**City of Portland, Oregon**  
**Bureau of Development Services**  
**Land Use Services**

**NOTICE OF A TYPE IIx DECISION ON A PROPOSAL IN YOUR NEIGHBORHOOD**

**CASE FILE NUMBER: LU 15-271166 LDS**

**Proposal:** The applicant requests a **Land Division-Subdivision** to divide a 5,000 square foot property into 5 lots for attached single dwelling houses. The applicant has a demolition permit (15-122338 RS) to remove the existing development.

A3 PRELIMINARY LAND DEVELOPMENT PLAN

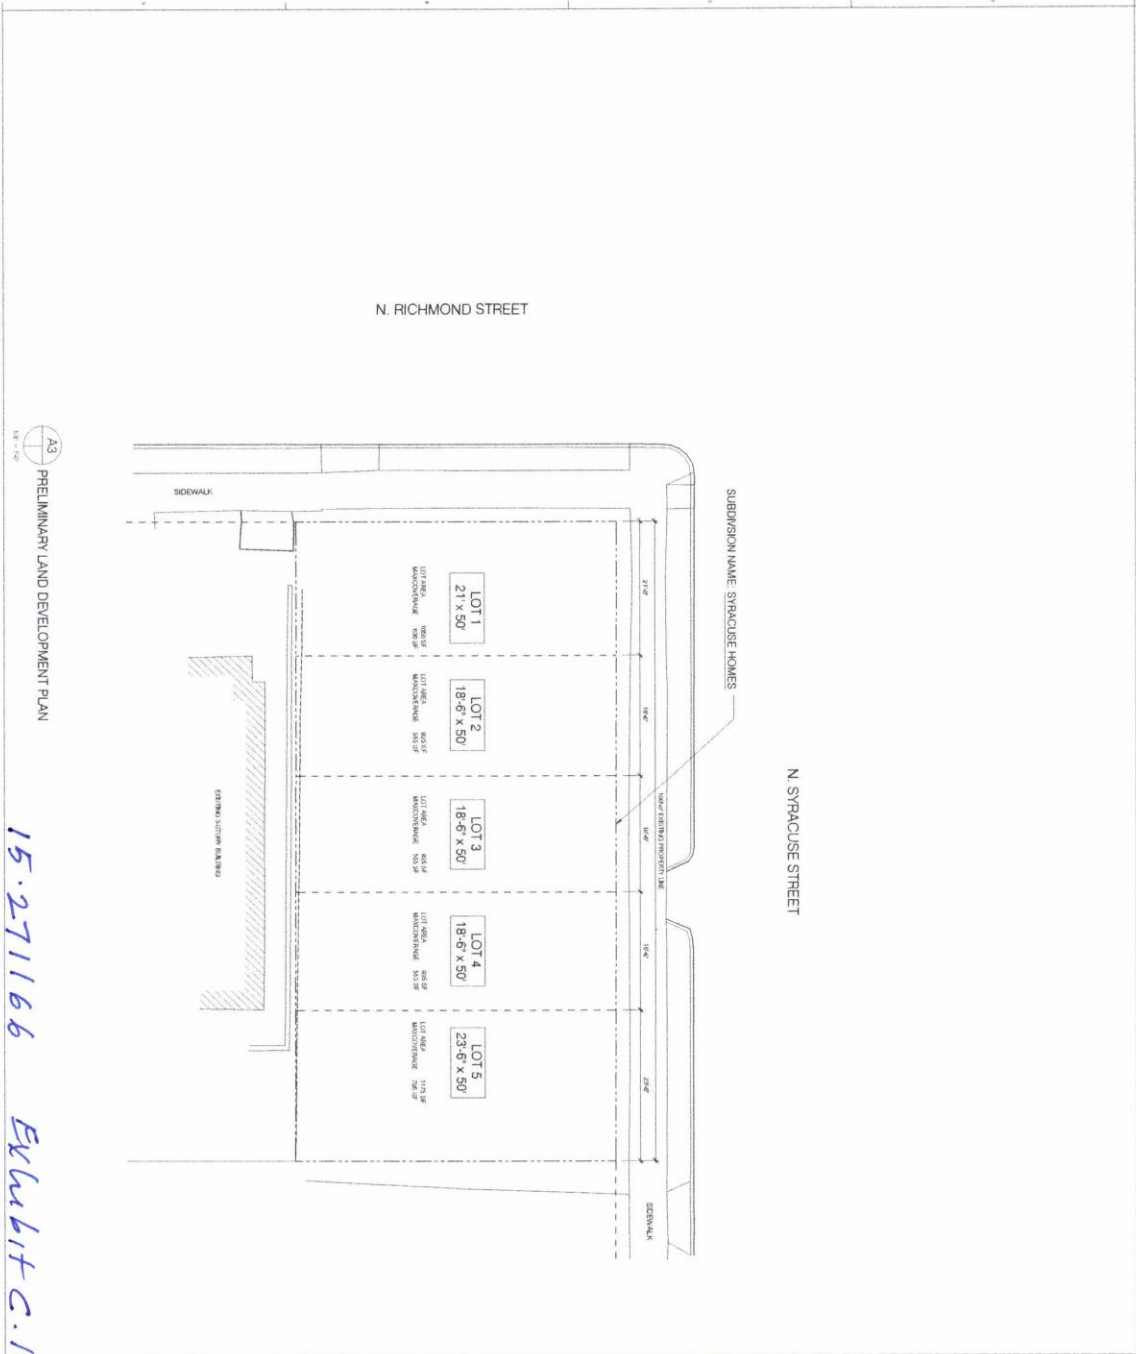
As shown on the submitted plans, the proposed development will include 2 shared driveways that will serve the homes on lots 2-5 (there is no on-site parking shown for the house on Lot 1). The shared driveways will reduce the available on-street parking by 2 spaces. With full occupancy of the 5 homes, assuming that 2 vehicles will park within each of the shared access driveways, and that the additional parking demand will be served by on-street parking, the on-street average peak parking demand is projected to increase by 5 spaces. Accordingly, it was estimated that 51 to 70 on-street average peak parking demand spaces will remain available within the study area following completion of the proposed development. Based on the available supply of parking in the vicinity of the lot partition in addition to the additional parking being provided by the development, adequate on-street parking is available to serve the proposed use in addition to the existing uses in the site vicinity.

*Shared Private Stormwater Systems: In order to share the private stormwater system as proposed, the applicant has [proposed] a private sewer easement across lot 2 for the benefit of lot 1, and an easement across lot 4 for the benefit of lot 5. BDS has approved plumbing code appeals for the shared stormwater systems that cross property lines and for easement widths less than 10 feet. For more information, see [BDS Appeals](#) page and search plumbing code appeal numbers 13551, 13553, 13554, 13568). BES will review the easement to ensure that it covers an approvable stormwater system for the included lots.*

*At this location, both of the site's frontages are improved with 4-6-2 sidewalk corridors. For Neighborhood Collector streets within (or in this case across the street from) a pedestrian district, the City's Pedestrian Design Guide requires a 15-ft wide sidewalk corridor (0.5-ft curb, 4-ft wide furnishing zone, 8-ft wide sidewalk and a 2.5-ft wide frontage zone). The site's existing 12-ft wide sidewalk corridor (and configuration thereof) does not satisfy the noted 15-ft wide standard corridor. **However**, in April of last year and in relation to a nearby apartment building that was constructed next door to the subject site, the Public Works Administrative Review Committee approved PW 14-139273 to allow the existing 4-6-2 sidewalk corridor to remain (along N Richmond) – no sidewalk corridor reconstruction to the 15-ft wide standard was required. **Accordingly**, the same decision has been rendered via PW 15-277197 - the proposed development on the subject site will not trigger sidewalk corridor widening along the site's N Richmond frontage.*

Richmond St and three trees to be planted on N Syracuse St. This plan does not meet the requirements of 11.50.060 for street tree planting along N Syracuse Street, which calls for 4 trees. Therefore, a fourth tree must be shown on N Syracuse Street or a fee of \$450 must be paid prior to final plat. Additionally, the tree planting must be shown on the building permit(s) at the time of development.

**Approval** of a Preliminary Plan for a 5-lot subdivision, that will result in 5 single dwelling lots, as illustrated with Exhibit C.1, subject to the following conditions:

1. A Private Storm Sewer Easement is required across the relevant portions of Parcels 1 and 2 for a shared stormwater facility that will provide stormwater disposal for both parcels.
2. A Private Storm Sewer Easement is required across the relevant portions of Parcels 4 and 5 for a shared stormwater facility that will provide stormwater disposal for both parcels.
3. A recording block for each of the legal documents such as maintenance agreement(s), acknowledgement of special land use conditions, or Declarations of Covenants, Conditions, and Restrictions (CC&Rs) as required by Conditions C.4 and C.5 below. The recording block(s) shall, at a minimum, include language substantially similar to the following example: "A Declaration of Maintenance Agreement for (name of feature) has been recorded as document no. \_\_\_\_\_, Multnomah County Deed Records."

1. A street tree planting plan must be provided to show the required street trees along the site's frontages to the satisfaction of Urban Forestry. If a fourth tree cannot be planted on N Syracuse St due to the land division configuration, a fee of \$450 must be paid in lieu of planting, prior to final plat.

1. The minimum and maximum density for each lot in this land division is one unit per lot.
2. Each lot must be developed with an attached dwelling unit.
3. The applicant must meet the addressing requirements of the Fire Bureau. The location of the sign must be shown on the building permit.
4. The applicant must provide a fire access way that meets the Fire Bureau requirements related to aerial fire department access. Aerial access applies to buildings that exceed 30 feet in height as measure to the bottom of the eave of the structure or the top of the parapet for a flat roof.
5. Street trees must be identified on the permit plans for the new residences to the satisfaction of Urban Forestry.
